Upper Occoquan Service Authority

For UOSA IFB 26-06 28/1 AWT Electrical Improvements

SUBJECT: Addendum # 1

28/1 AWT ELECTRICAL SERVICES RENEWAL
UOSA CONTRACT 22-06STA

BUILDING P FLOOR PLAN

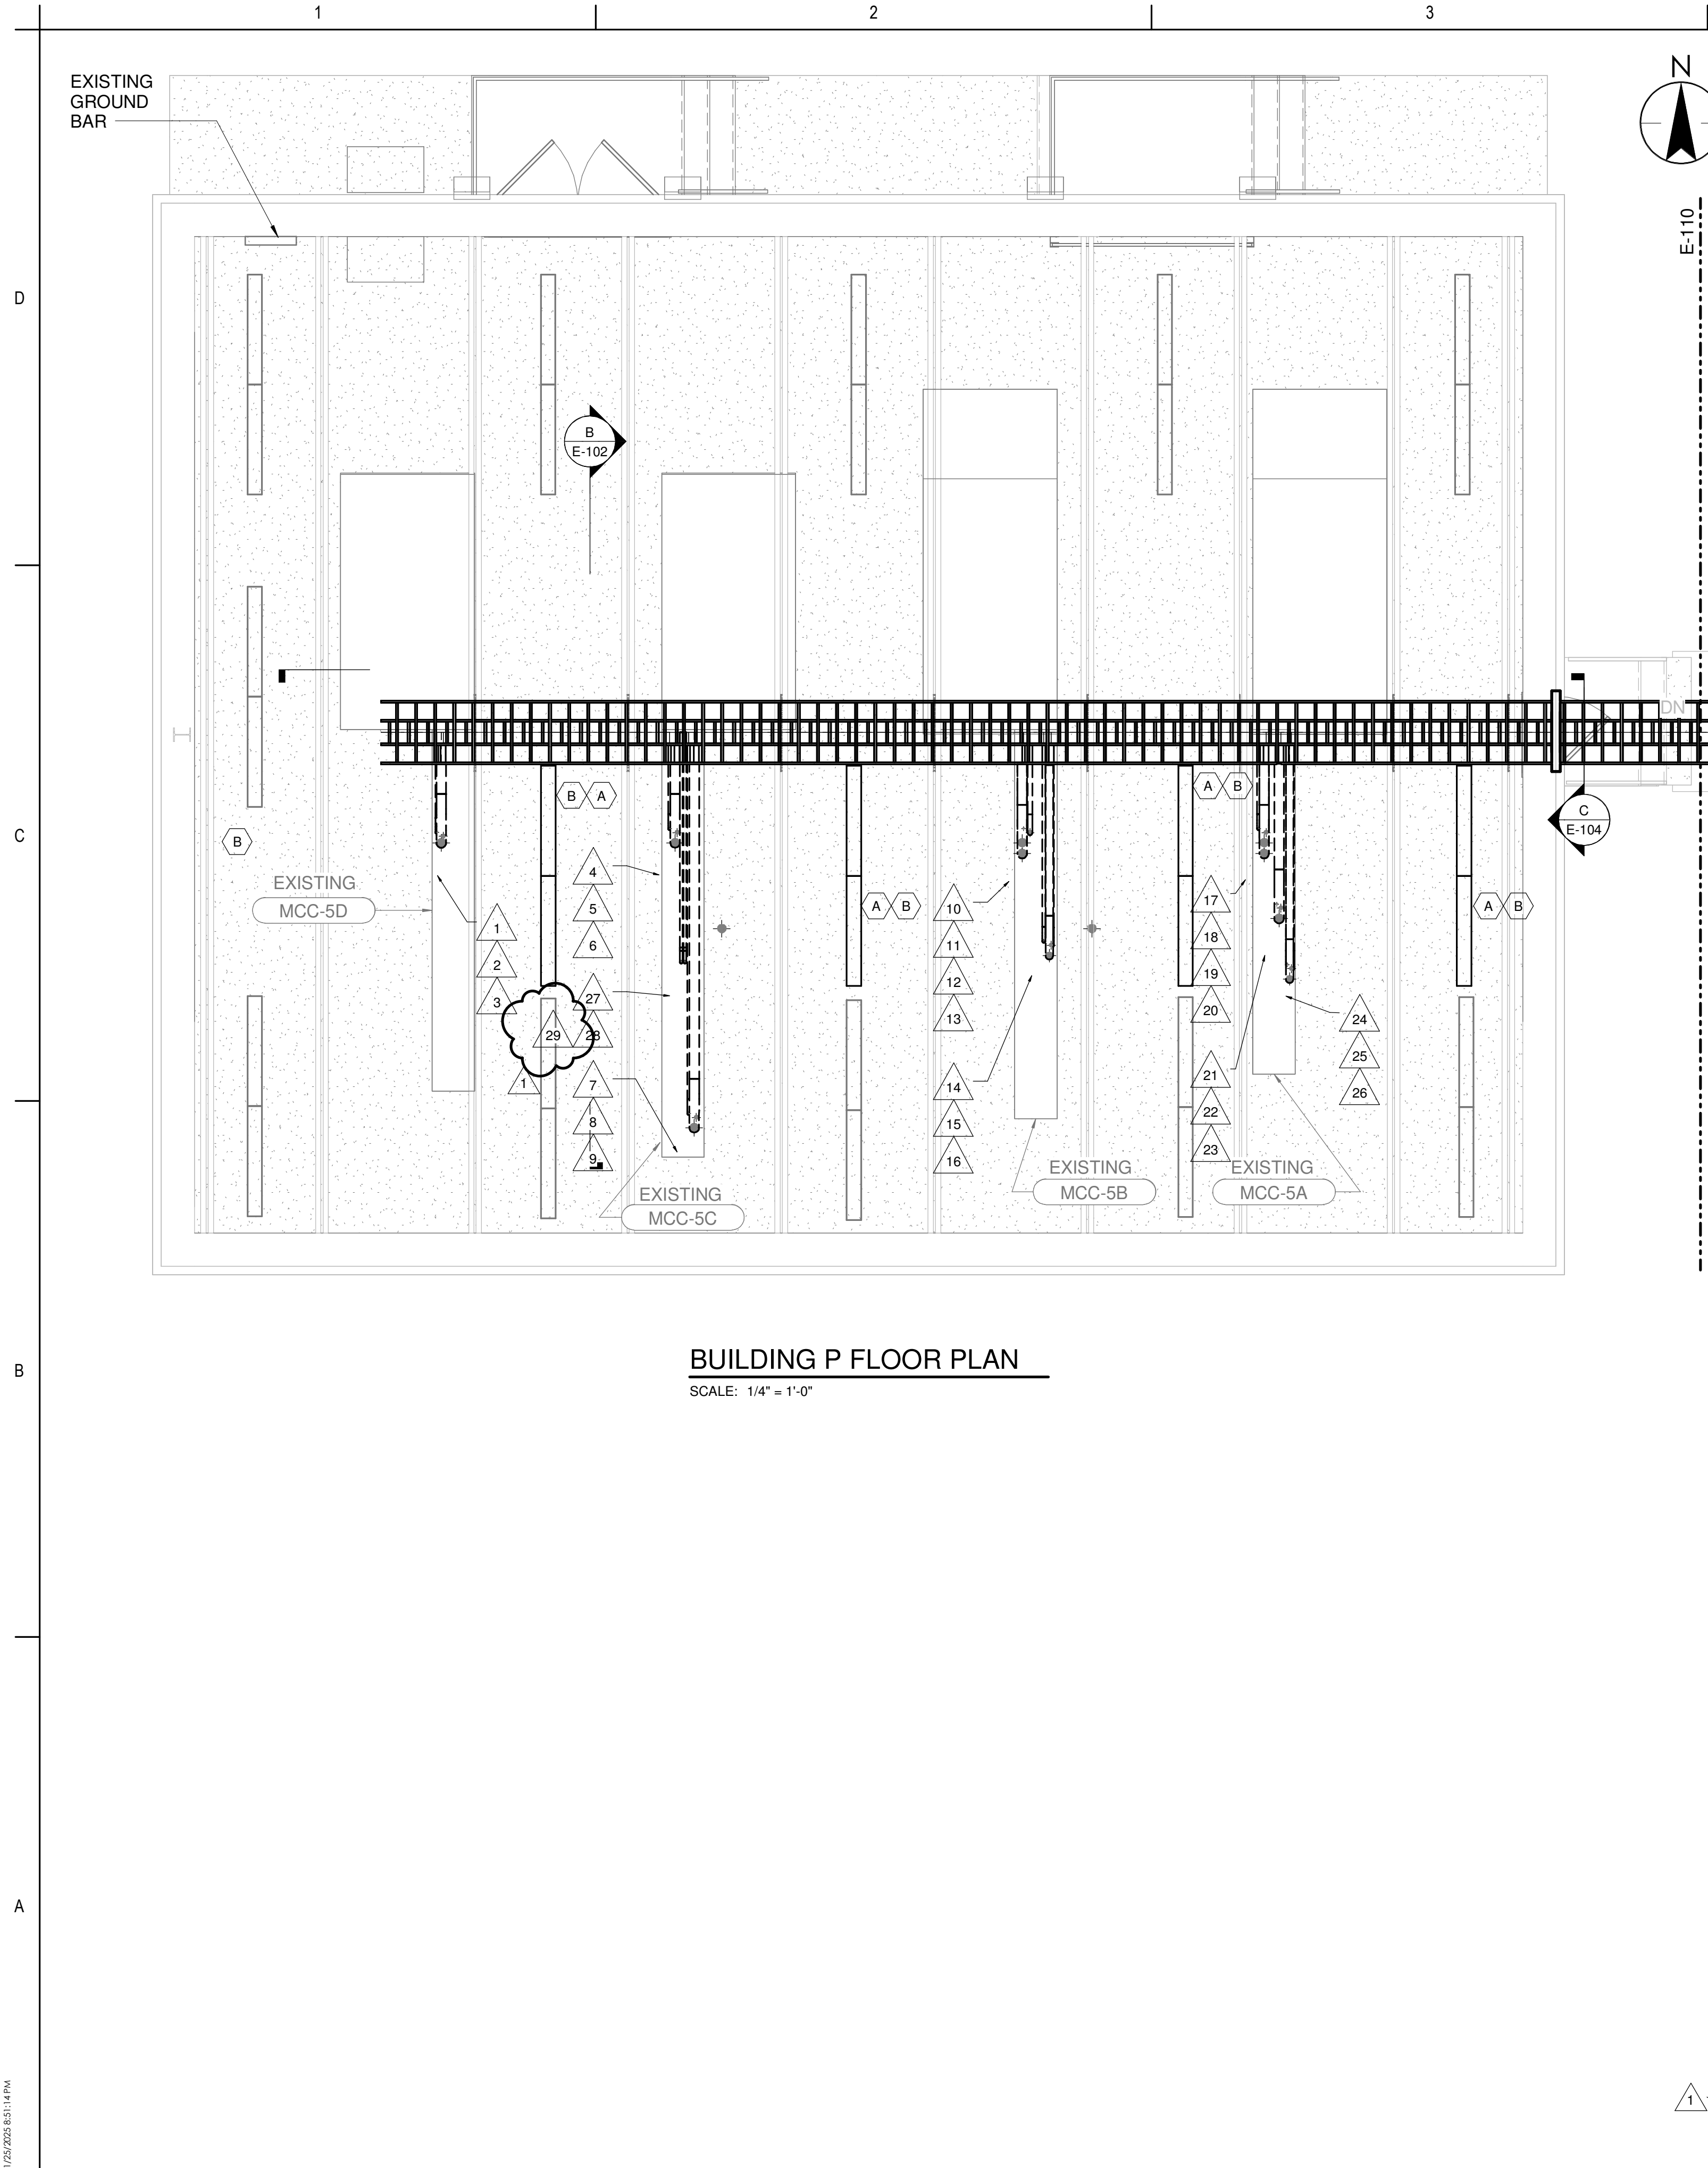
Q1: Please confirm per the conduit and cable schedule on sheet E-101 that the (2) 3/0 awg and typical entries requires 2 sets of 3 phase 3/0 with a ground and without a neutral.

Q5: On the conduit and cable schedule (example below) the power conductors show (2) 3/0 AWG or (2) 250KCMIL. Does this mean two (2) conductors or possibly two (2) sets of conductors? I assume that these are 3-phase 480V motors, without the MCC one-line to work with. I need to know if these are going to be parallel feeders to the motor as that would double to amount of wire necessary.

A: Confirmed, 2 sets of 3 phase ###awg/Kcmil with a ground and without a neutral. See revised Drawing E-101 with a clarifying note.

A: (2) indicates two, parallel sets of conductors.
